***Technical Review — Crown Pillar Subsidence  
and Hydrologic Stability Assessment  
for the Proposed Eagle Mine  
(DRAFT)***

Prepared for:  
MFG, Inc  
Michigan Department of Environmental Quality

Prepared by:  
David Sainsbury, Ph.D.  
Itasca Consulting Group, Inc.

Ref: ICG06-2376-23D

**Figure 3 Comparison between equivalent UCS obtained using outdated method and the current ISRM and ASTM methods assuming the default conversion factor of 24**

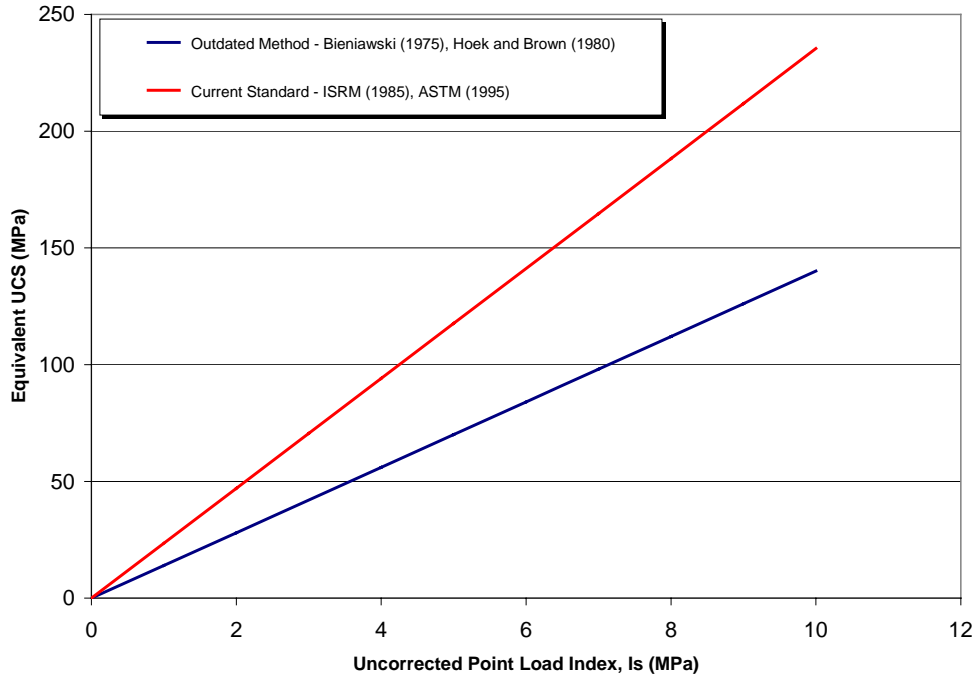
Unconfined compressive strength tests were not used to calibrate the point load test results within the Eagle Project Geotechnical Study (Golder, 2005). The ASTM Standard Test Method D 5731 95 (ASTM, 1995) states that point load test results alone should not be used for design or analytical purposes.

The procedure used to determine the point load index and equivalent UCS within the Eagle Project Geotechnical Study (Golder, 2005) is based on an outdated method originally proposed by Bieniawski (1975) and later reported by Hoek and Brown (1980). This method

is not consistent with the current International Society of Rock Mechanics (ISRM) suggested method for determining point load strength (ISRM, 1985) or the ASTM standard test method for determining the point load strength index of rock (ASTM, 1995). The current standard methods apply a size correction factor and a UCS correlation factor to the uncorrected point load strength index. Figure 3 illustrates the significant difference that can be obtained when using the current standard point load determination method with the default conversion factor (24), compared to the outdated methods.

The point load testing approach that was adopted for the Eagle Project Geotechnical Study (Golder, 2005) causes significant uncertainty in the intact rock strength that was determined for each lithological unit. The approach is not consistent with industry best-practice and causes significant uncertainty with the rock mass classification rating applied to each unit. This, in turn, has an effect upon all subsequent design calculations that rely upon the rock mass rating, as well as the determination of rock mass mechanical properties for numerical modeling.

**Figure 4** Increase in  $UCS_{rock\ mass}$  with increasing GSI or RMR<sub>76</sub>

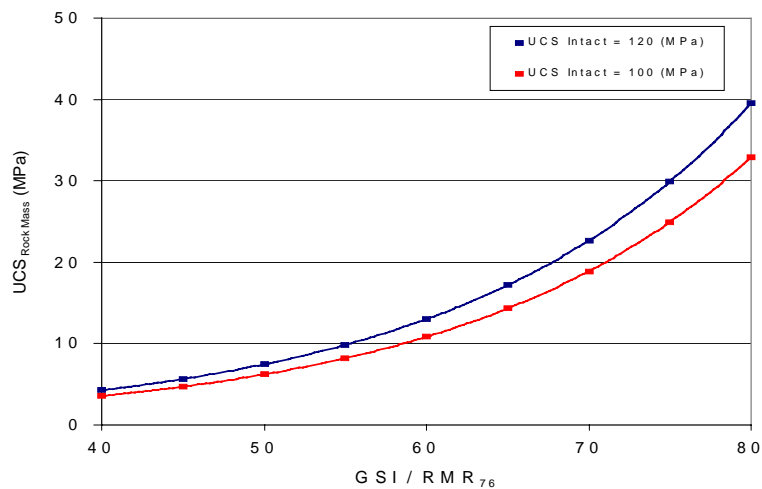
The actual version of RMR scheme used throughout the Eagle Project Geotechnical Study (Golder, 2005) has not been referenced, and the description of the scheme used within the text of the report is not consistent with either the RMR<sub>76</sub> or RMR<sub>89</sub> scheme. Clarification by Golder (2006c) indicates that the actual RMR scheme used was RMR<sub>76</sub>, although a typographical error was made within the text in which the maximum rating for ground water condition (A5) was reported as 15 rather than 10.

A groundwater condition rating of 10 assumes completely dry conditions. This is a non-conservative assumption, and it is not consistent with the bedrock hydrogeological investigation (Golder, 2006b) or the limit-equilibrium crown pillar analysis, in which completely saturated conditions were assumed. The typical RMR<sub>76</sub> value assigned to the peridotite crown pillar originally was calculated to be 75 (Golder, 2005). This was later reduced to a value of 70 (Golder, 2006a).

Although the derivation of a particular rock mass rating can be subjective, it is important to note that the relation between rock mass rating and rock mass strength is an exponential function, as illustrated in Figure 4. At high RMR<sub>76</sub> values, a minor variation in rating results in a significant variation in the equivalent rock mass strength.

**Figure 5** Variation of *k* ratio with depth based upon Herget's (1988) equation

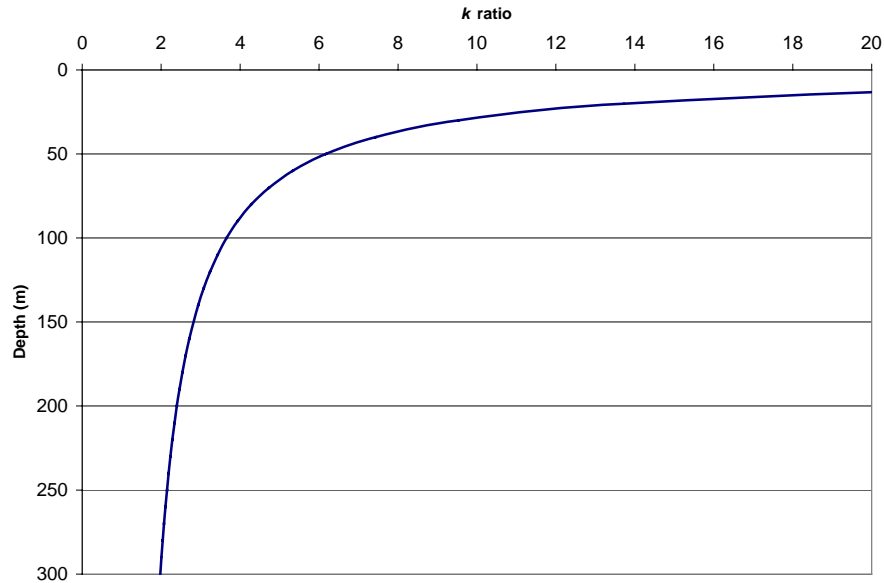
The *k* ratio assumed throughout the Eagle Mine Geotechnical Study (Golder, 2005 and 2006) was 2.0. This is based on an equation proposed by Herget (1988) to predict horizontal stresses for underground excavations in the Canadian Shield rock units:

A depth of 300 m was used to determine the *k* ratio of 2.0. However, near the surface in the area of the crown pillar, Herget's equation predicts significantly higher *k* ratios, as illustrated in Figure 5. Assuming a depth of 50 m, the predicted *k* ratio is 6.2.

Without further analysis, it is not clear how the increased *k* ratio would affect the behavior of the proposed crown pillar. Based upon the excessive horizontal stresses observed at the White Pine Copper Mine, a sensitivity study should be conducted to determine the crown pillar behavior under a variety of possible horizontal stress conditions.

**Figure 6** *Phase<sup>2</sup> model geometry and finite element mesh (Golder, 2006c)*

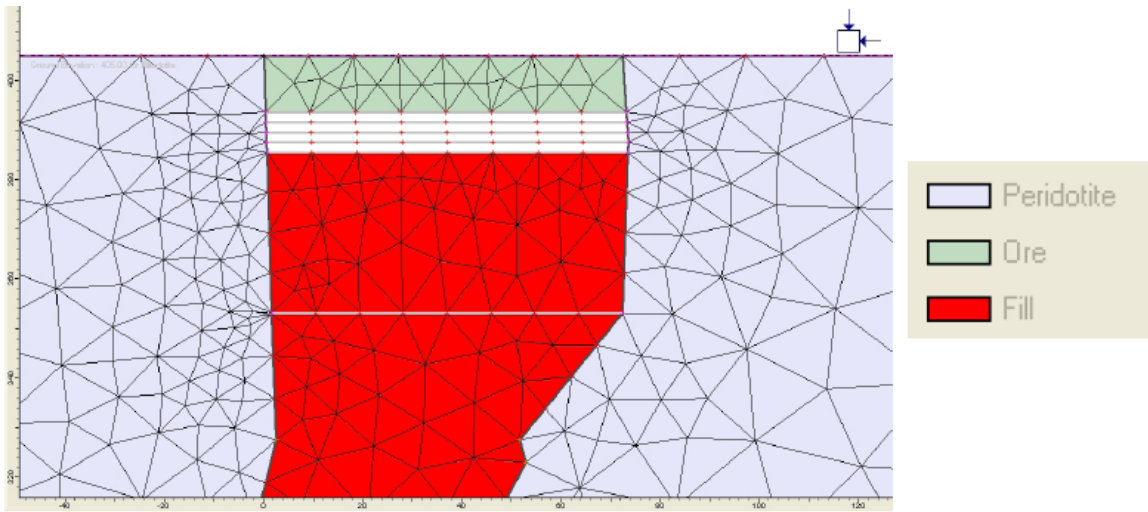
Figure 6 illustrates the two-dimensional model geometry used to investigate crown pillar subsidence with the Phase<sup>2</sup> code. The two-dimensional, plane-strain analysis assumes that the crown pillar span is 68 m and infinitely long. The actual span is approximately 50 m, and its length is approximately 68 m.

The model is not considered to be realistic, as the finite element mesh used to discretize the crown pillar is extremely coarse and severely limits the accuracy of the modeling results. Only one or two three-noded triangle elements have been specified across the thickness of the crown pillar. The default value suggested within the Phase<sup>2</sup> program to ensure accurate modeling results is 10 elements (RocScience, 2005a).
